# IEEE P802.3bt PSE State Diagram Update

Dan Dove, DNS for LTC

*May 15, 2015*

# Defining Blocks & Identifying Arcs

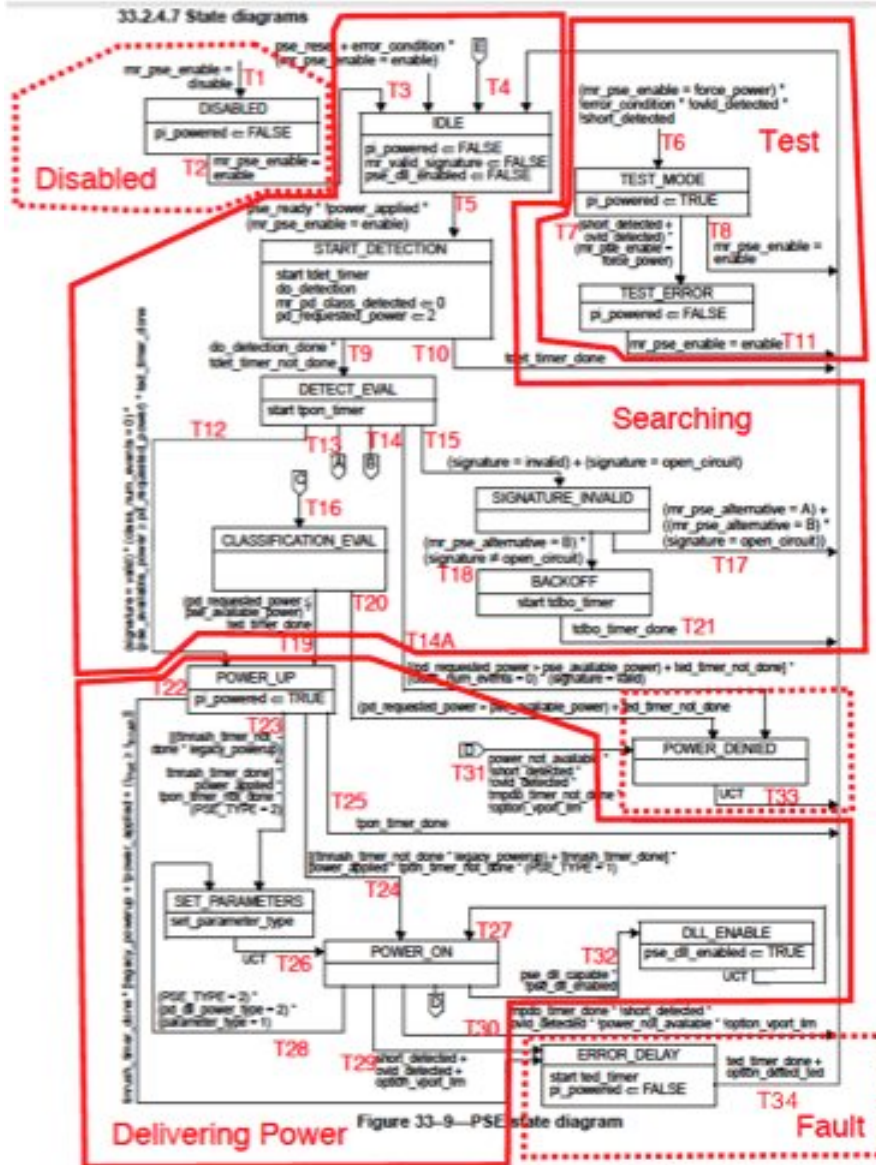
Removed T35

Moved T34 (already T27) to Fault  
output to RTI (Formerly T35)

# Searching

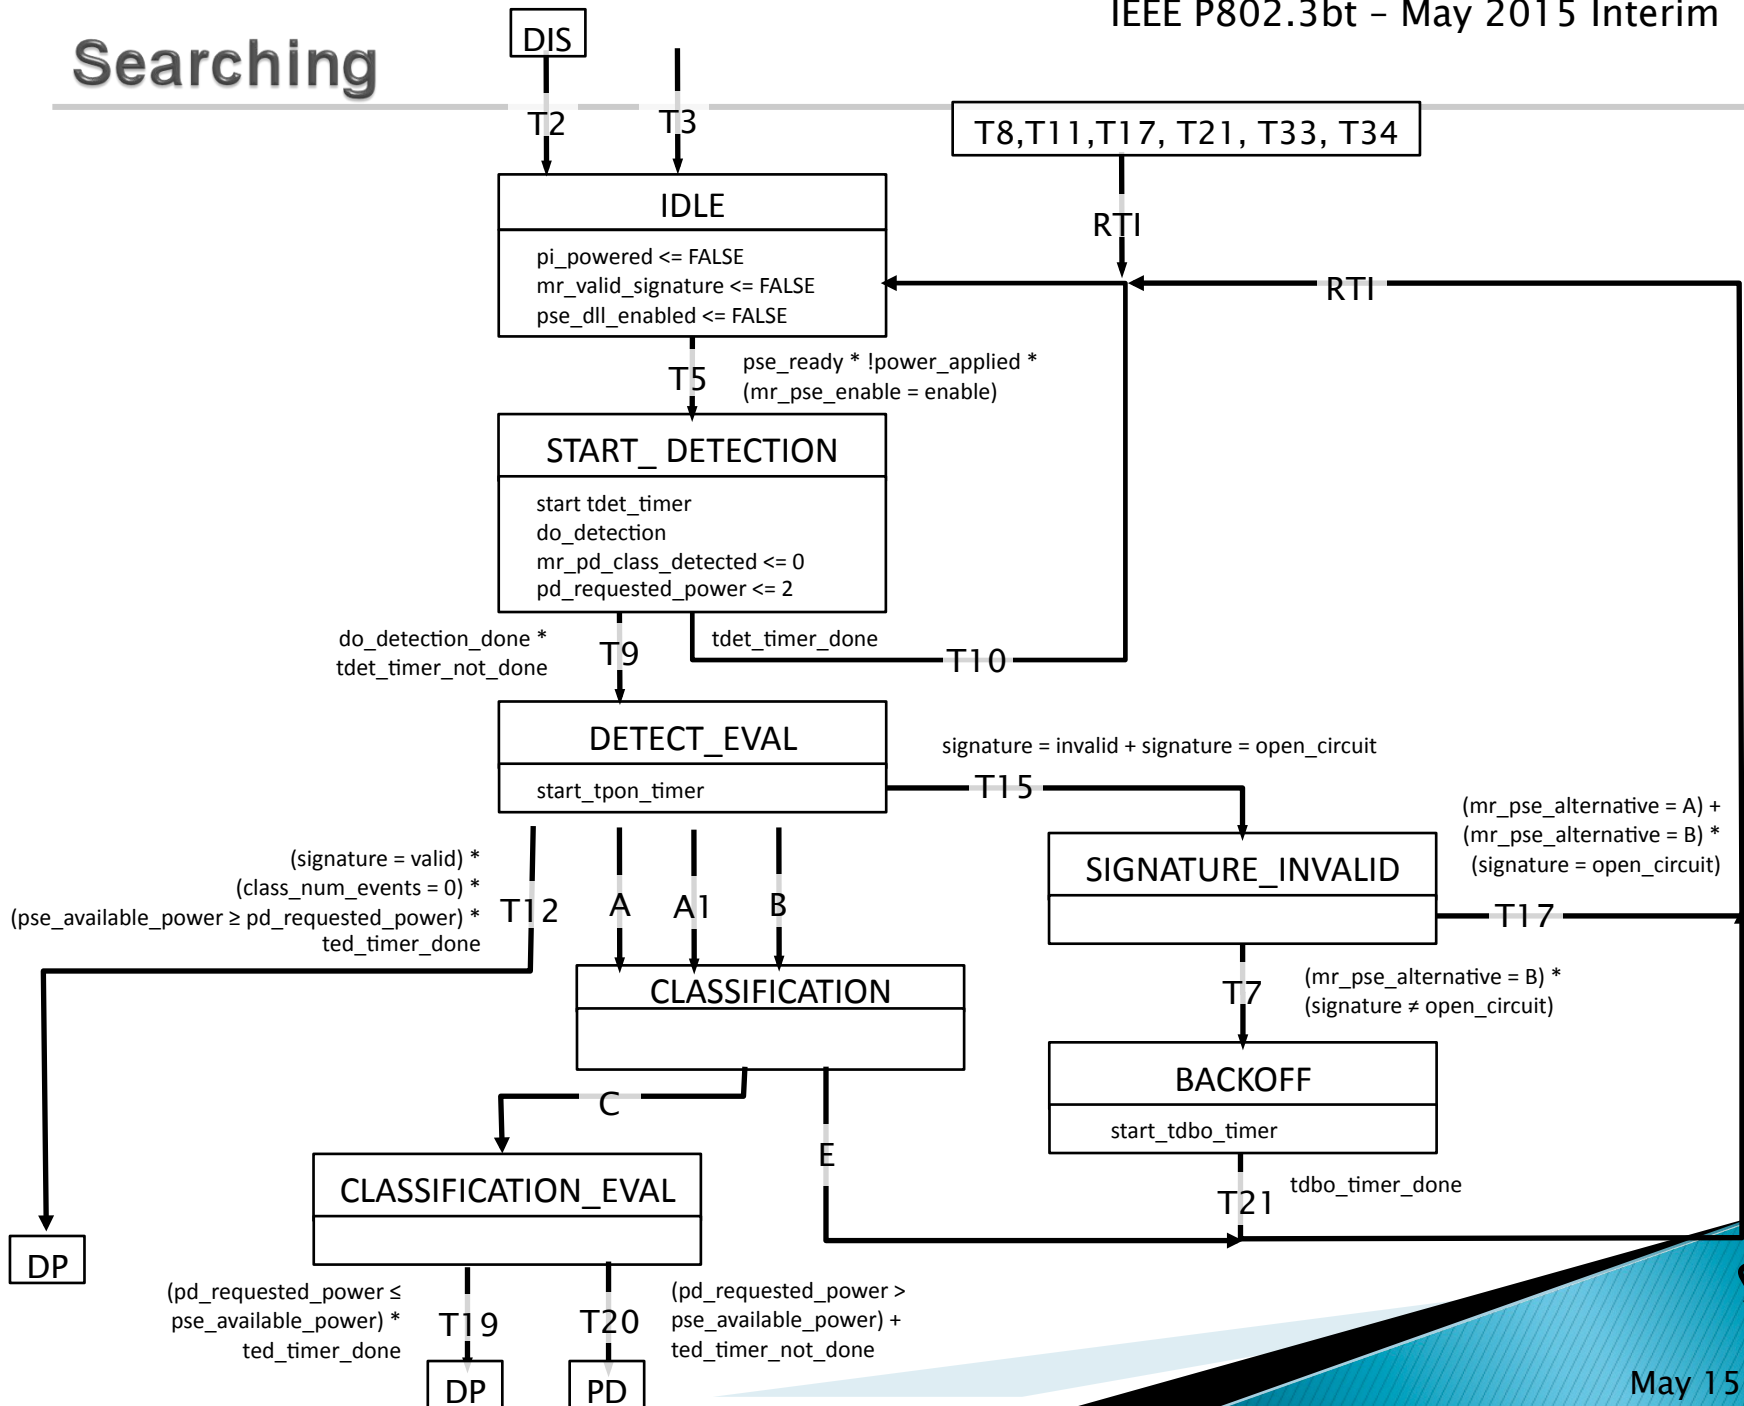
- A typo taken out of T23 (removed hyphen)
  - A1 arc added to “Searching” block since it appears as entry into the Classification State
- It’s the author’s opinion, that a good specification is done from the top down, rather than the bottom up. The existing PSE state diagram, while it accurately represents behavior of a PSE, appears to have been designed from the bottom up to explain PSE behavior, rather than to direct design.
